LINCOLN PARK PLANNING COMMISSION

881 Southfield – Auto Sales

Site Plan Review

Applicant	Roger Canzano
Project	Auto Sales
Address	881 Southfield Rd. Lincoln Park, MI 48146
Date	September 8, 2021
Request	Site Plan Review

SHEET TITLE
PROJECT NAME
 ADD USED CAR SALES TO
 EXISTING AUTO REPAIR
SITE PLAN

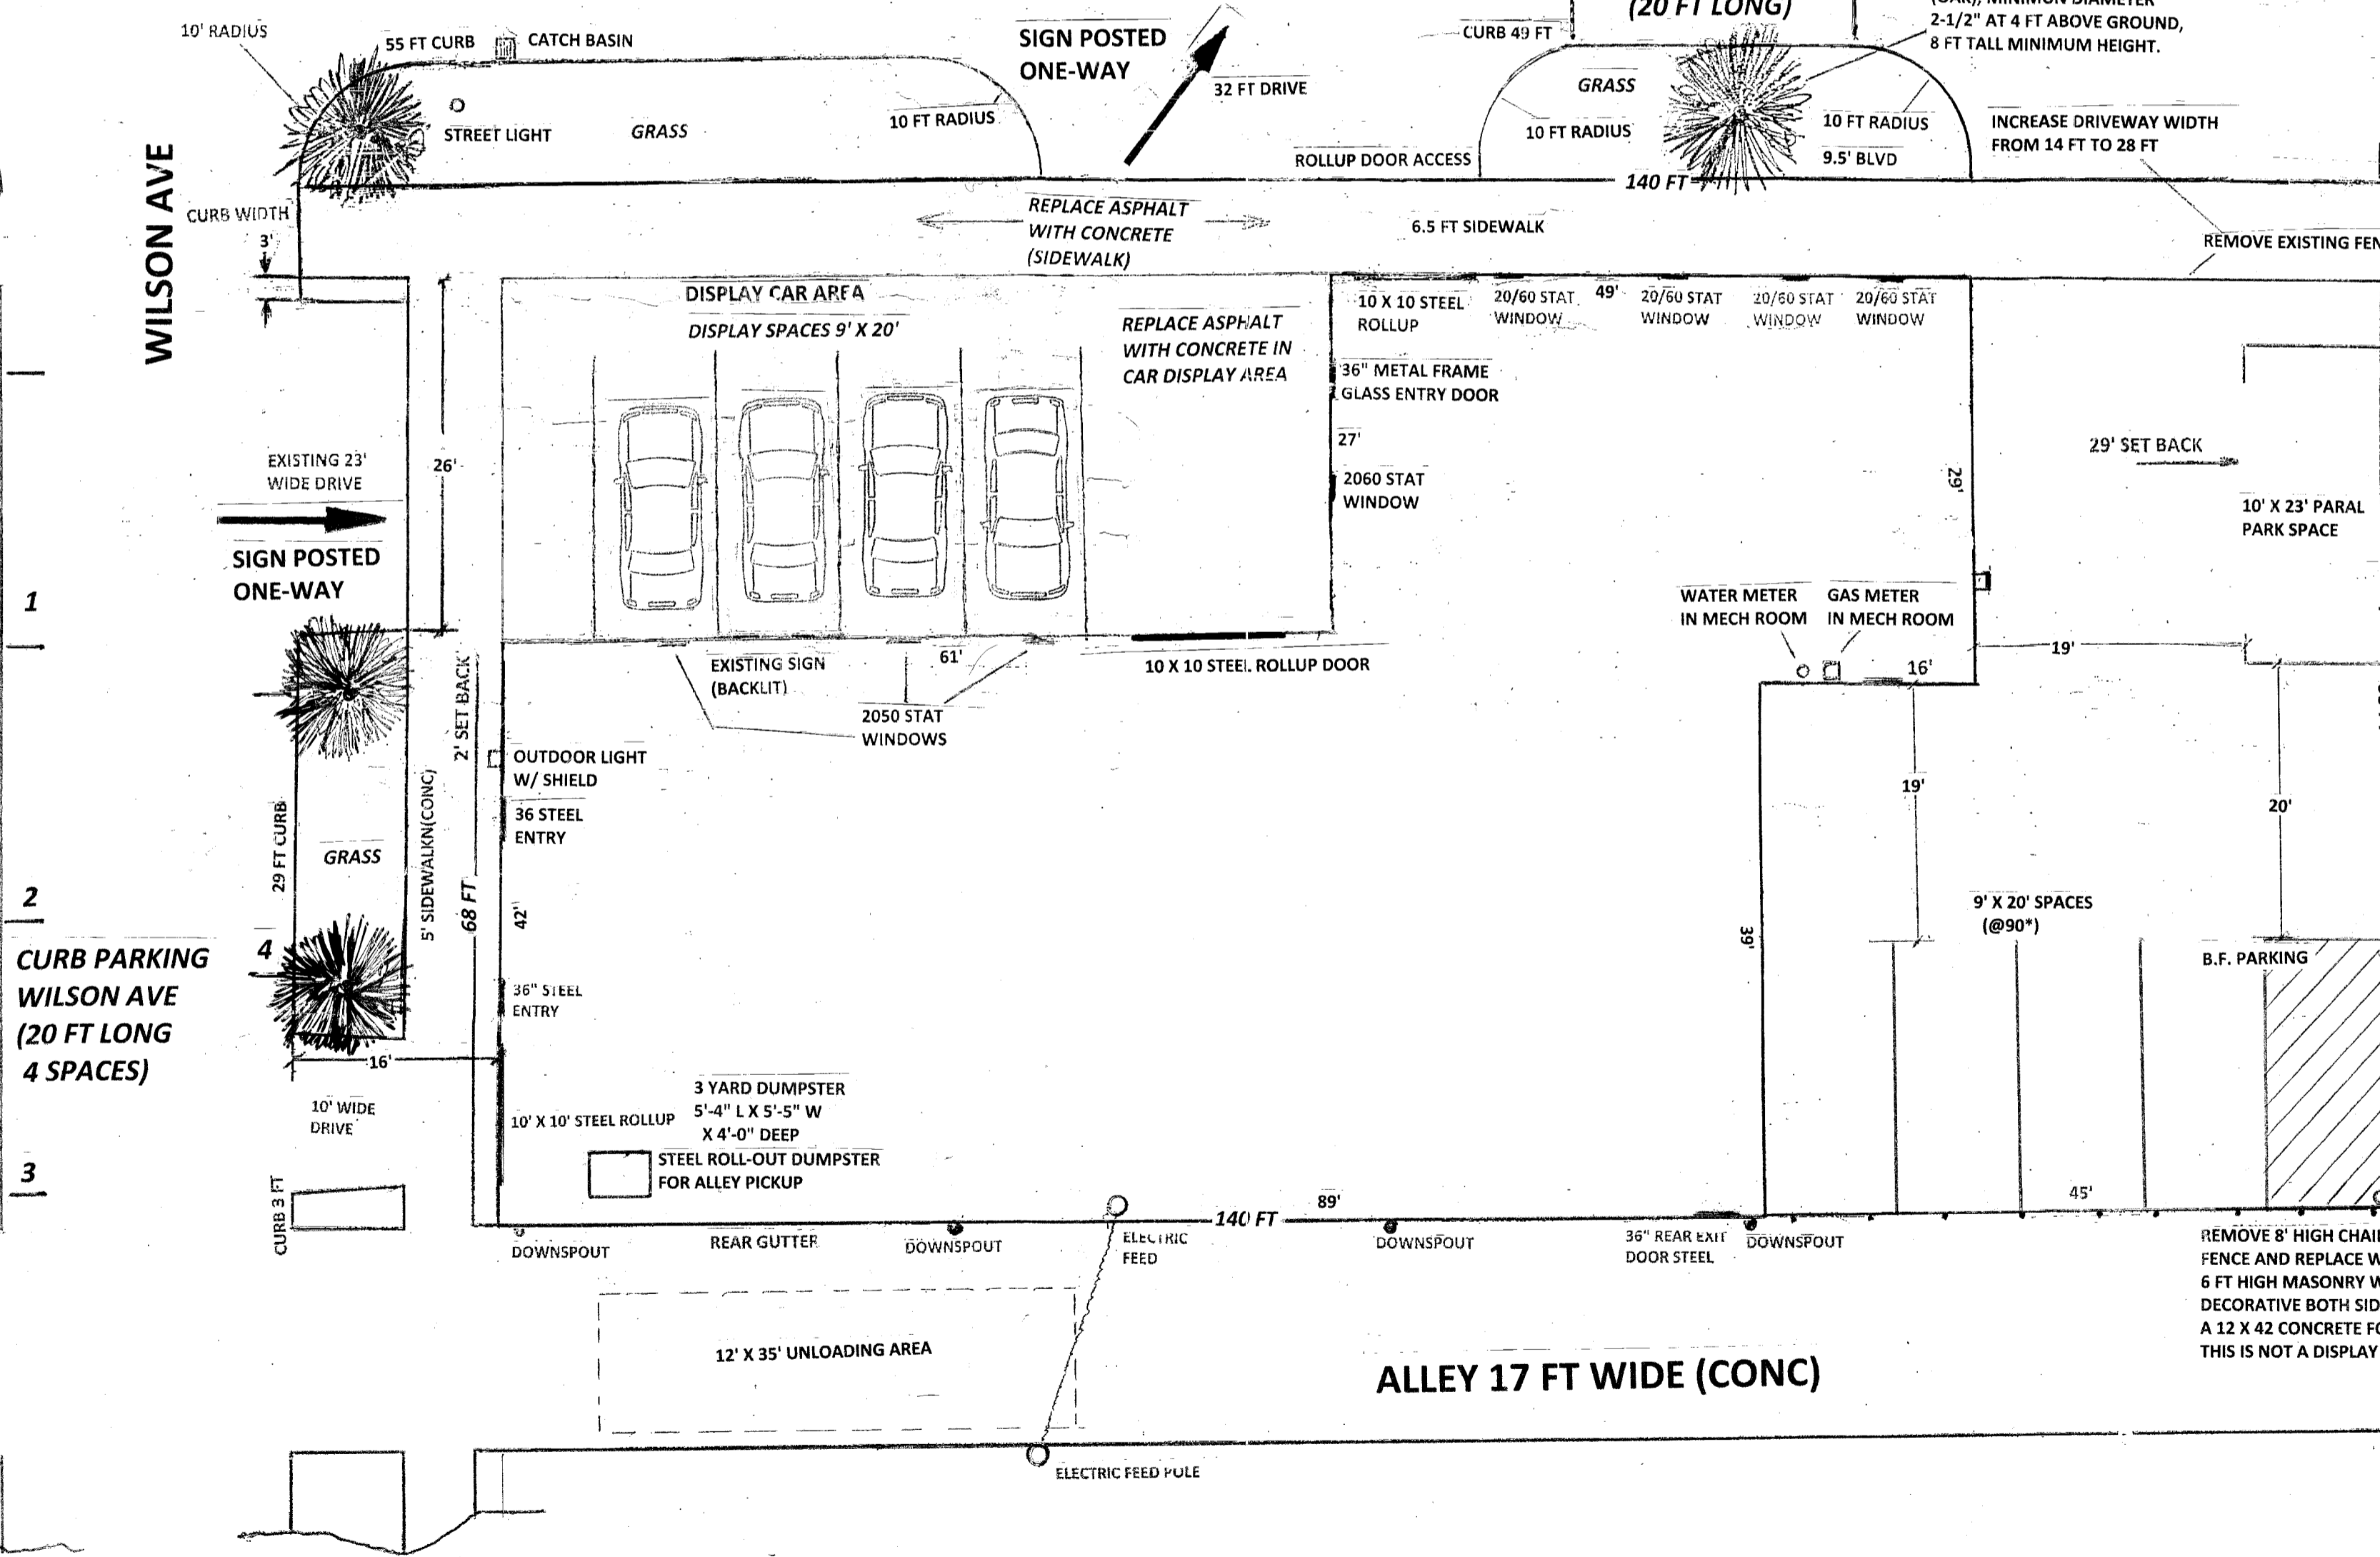
The site is served by a 5-ft concrete sidewalk at Wilson Ave followed by an 8-ft asphalt Blvd with few to no curbs. Also, the sidewalk discontinues at the property line at Southfield Rd, and it reappears at the far east side of the property. This existing condition presents a dominant vehicular circulation without consideration for safe pedestrian circulation (see Figure 5). The applicant proposes a 6.5 ft concrete sidewalk along Southfield Rd that connects the Wilson Ave sidewalk with the sidewalk on Southfield Rd to provide a safe pedestrian circulation. Existing conditions show cars parked in the proposed sidewalk area, to be removed. The applicant also proposes to remove the asphalt between the sidewalk and Southfield Rd along the entire property frontage and replace it with sod; these are addressed under Landscaping, below. There are no bicycle facilities along the ROW or bicycle parking facilities proposed.

The site plan proposes a total of six (6) spaces for the site along with four (4) on-street parking spaces along Wilson Ave. and one on-street parking space along Southfield Rd. The proposed use requires eight (8) spaces, and the Planning Commission has the power to waive this requirement based on evidence of lower demand.

Required Spaces	Required Barrier-Free Spaces	Proposed Barrier-Free Spaces	Compliance
1 to 25	1	1 that measures 9' in width	NOT MET

The site is served by an existing light pole located on the corner of Southfield Rd and Wilson Ave. The Site Plan, sheet 01 and Elevations, sheet 06 indicate two outdoor light fixtures with shields, one on the left side elevation facing the auto display area and one on the left side elevation facing the Wilson Ave. The existing lighting appears to be shielded and downward facing.

The proposed use is expected to generate some quantity of hazardous materials or waste. Sheet 01 Site Plan notes that the applicant will provide primary and secondary containers inside the building for the storage of removed vehicle fluids. Applicant shall provide documentation of compliance with State and Federal standards for storage, use, handling, and disposal.

6. The current plans do call for a new 6.5 foot walk along the front of the building.
7. The plans do call for replacing the existing asphalt parking lot in front of the building. Pavement details and cross-sections can be provided at the time of the detailed engineering review.
8. The plans call for parking on the east side of the building. This area on the east side of the building is concrete in very good condition. The parking lot calls for new striping.
9. The east drive approach from Southfield Road will remain unchanged.

- Applicant shall ensure that existing and new concrete sidewalks are brought up to City standards.
- Applicant shall provide details and cross sections of the proposed sidewalk at the time of the detailed engineering review.
- Applicant shall ensure that no cars will be parked from the proposed sidewalk to the road.

- A parking waiver is requested from the Planning Commission to reduce the number of required parking spaces from 8 to 6. Factors for consideration are the size constraints of the site and the availability of on-street parking.
- Applicant shall replace the existing asphalt and bring all parking areas up to City standards.
- Applicant shall provide pavement details and cross-sections at the time of the detailed engineering review.

- Applicant shall provide the one required barrier-free parking space that is 12' wide.

- Applicant shall provide documentation of compliance with State and Federal standards for storage, use, handling, and disposal of hazardous materials and waste.*

ELEVATIONS

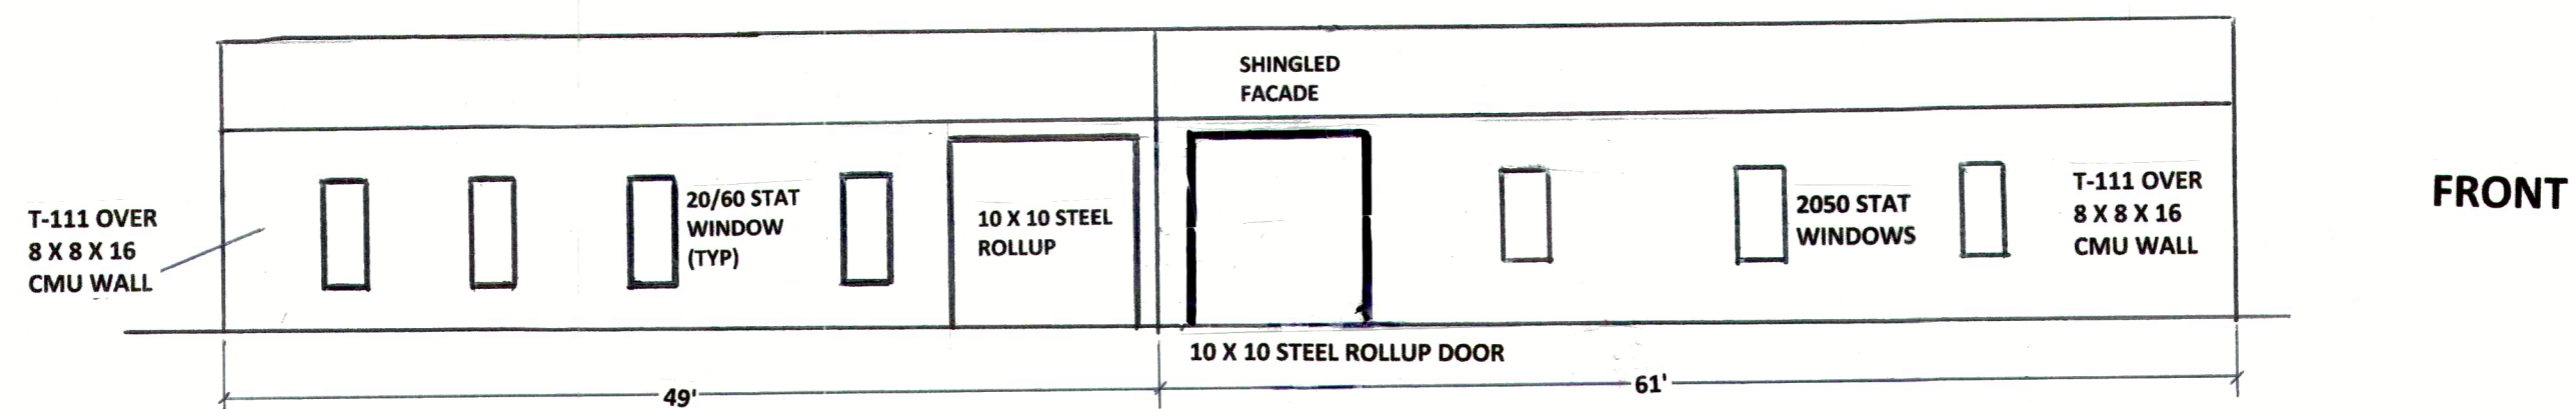
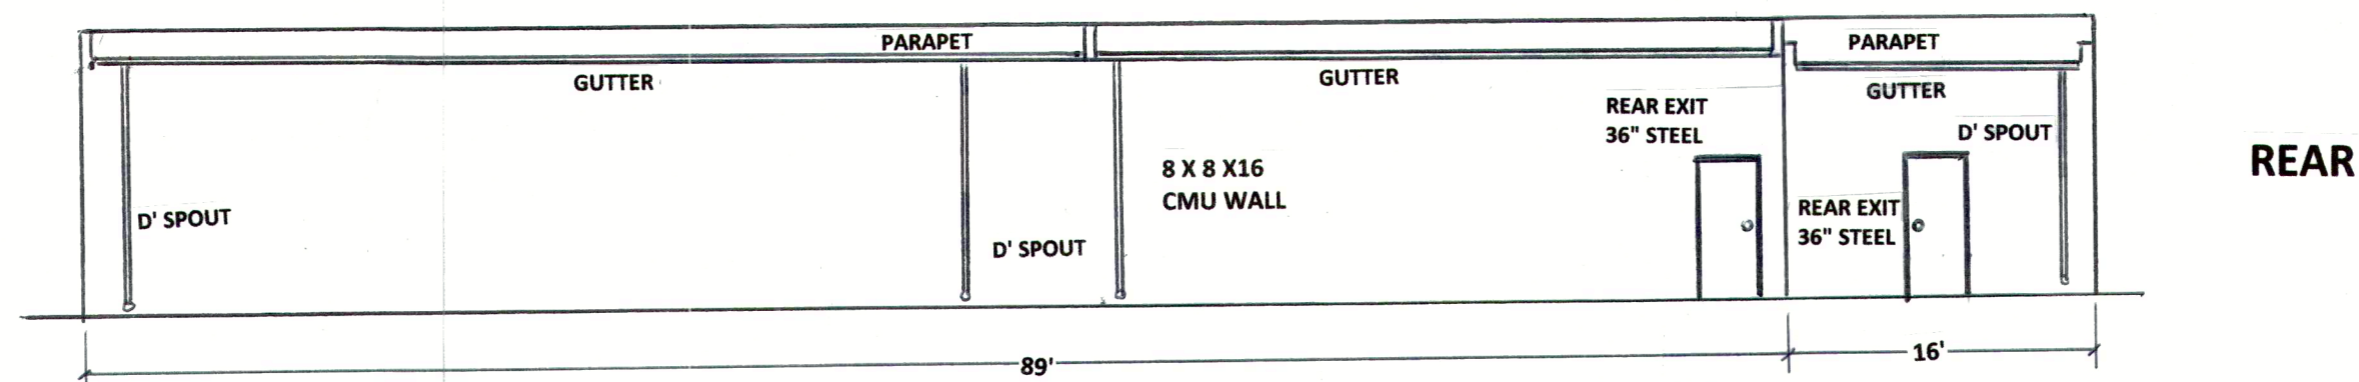
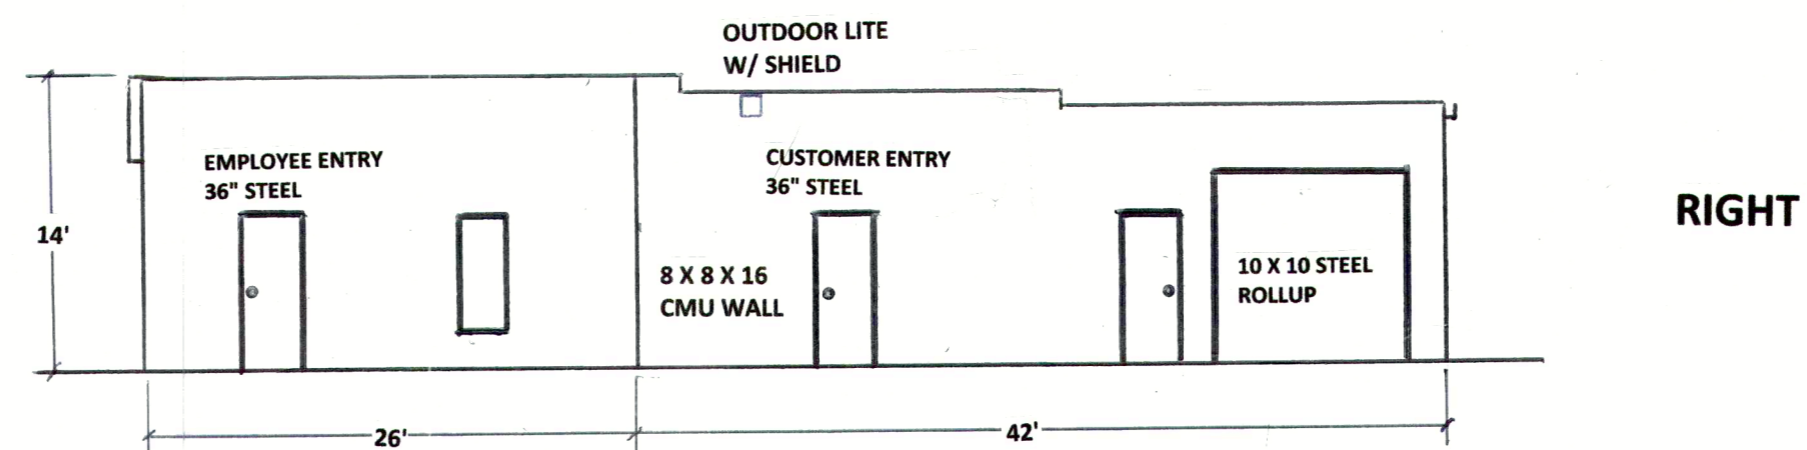
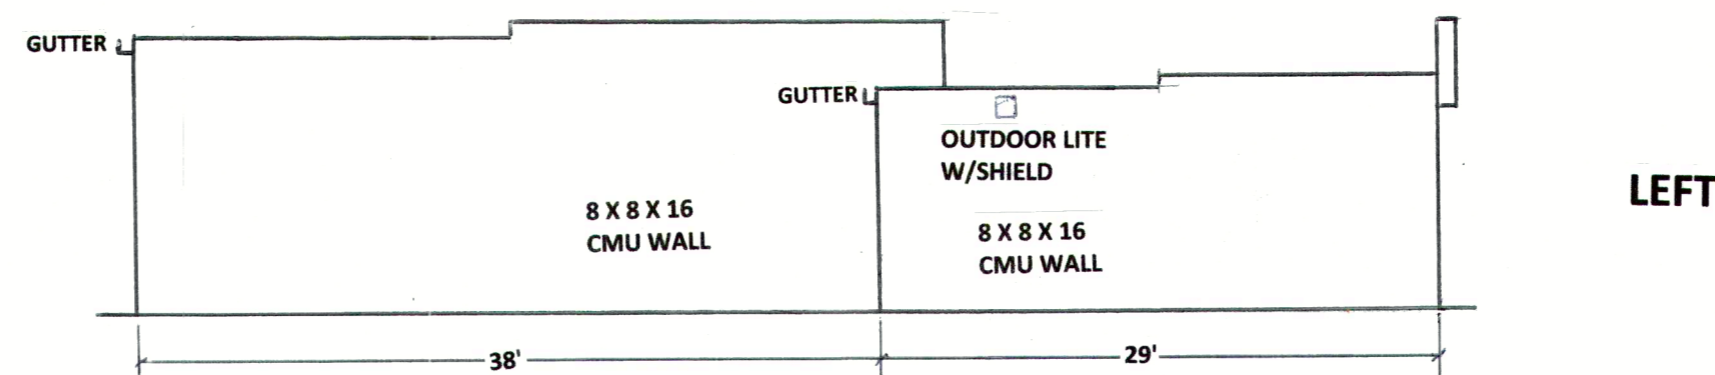
Required	Compliance
<ul style="list-style-type: none"> Building mass, height, bulk and width-to-height ratio within 50-150% of buildings within 500' 	Met
<ul style="list-style-type: none"> Architectural variety Similar materials and entrances to buildings within 500'  <p>Figure 3: The site; Southfield Rd and Wilson Ave corner</p>  <p>Figure 4: Southfield Rd looking East</p>	Met
<ul style="list-style-type: none"> Building materials: primarily natural products conveying permanence (brick, decorative masonry block, stone, or beveled wood siding) = 75% of each façade (industrial districts, 50% if facing ROW) <u>Front (facing Southfield): 58% (878 sf / 1525 sf)</u> Beveled wood siding over CMU wall: 878 sf Shingled roof: 467 sf Windows (exempt): 86 sf Metal doors: 180 sf Total: 1,611 sf <u>Rear (facing alley): 87% masonry (1,338 sf / 1,543 sf)</u> CMU wall: 1,338 sf Parapet: 159 sf Metal doors: 46 sf Total: 1,543 sf <u>Right (facing Wilson): 81% masonry (785 sf / 965 sf)</u> CMU wall: 785 sf Shingled roof: 3 sf Window (exempt): 15 sf Metal doors: 177 sf Total: 980 sf <u>Left (facing east): 99% masonry (927 sf / 931 sf)</u> CMU wall: 927 sf Shingled roof: 4 sf Total: 931 sf 	NOT MET

Required	Compliance
<ul style="list-style-type: none"> 25% may be glass, exterior insulation finish systems (EIFS), vinyl, aluminum, or steel siding; or similar synthetic or highly reflective materials (industrial districts not facing public streets or freeways, these and pre-cast concrete or plain masonry block) Natural colors (bright for decorative features only). <i>Front and West facades are painted in dark grey color; East and Rear facades are painted tan.</i> 	
<ul style="list-style-type: none"> Façade: <100' uninterrupted If >100' = recesses, off-sets, angular forms, arches, colonnades, columns, pilasters, detailed trim, brick bands, contrasting courses of material, cornices or porches All sides similar 	Met
<ul style="list-style-type: none"> Windows: vertical, recessed, visually obvious sills Spaces between windows = columns, mullions, or material found elsewhere on façade Front facades > 25% windows <i>Southfield Rd: ~5% transparency (86 sf / 1,611 sf); Wilson Ave: ~1.5% (15 sf / 980 sf)</i> Size, shape, orientation, spacing to match buildings within 500' 	NOT MET

The building materials and transparency (windows) do not meet the standards but may be preserved so long as the nonconformity is not increased. As the proposal does not include changes to the building façade, the City has historically permitted existing façade conditions to remain.
